NOTIFICATION – JAN 06 2020

Engine mount cracks - Rotax

Chris Heintz (CH) aircraft models with Rotax 912 bed mount

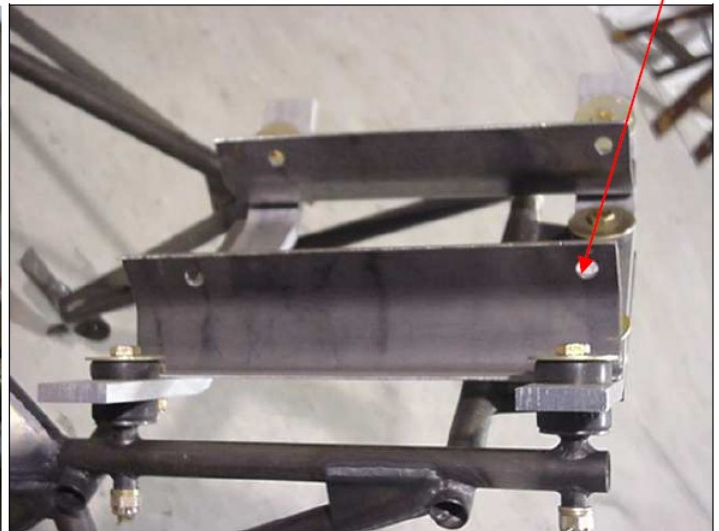
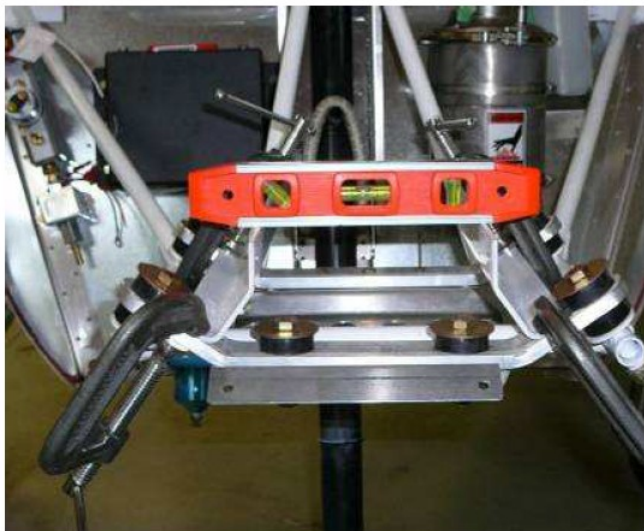
A Zodiac CH 601HD customer found cracks on his engine mount. We also had a customer find cracks on the engine mounting brackets. See attached photos. It is our experience that many airframe issues start from excessive vibrations and improper installation.

Thoroughly inspect your engine mount, and everything else including E1-1X steel brackets. Check for cracks, loose screws etc.

If cracks are found, stop flying the aircraft. Remove the part and replace.
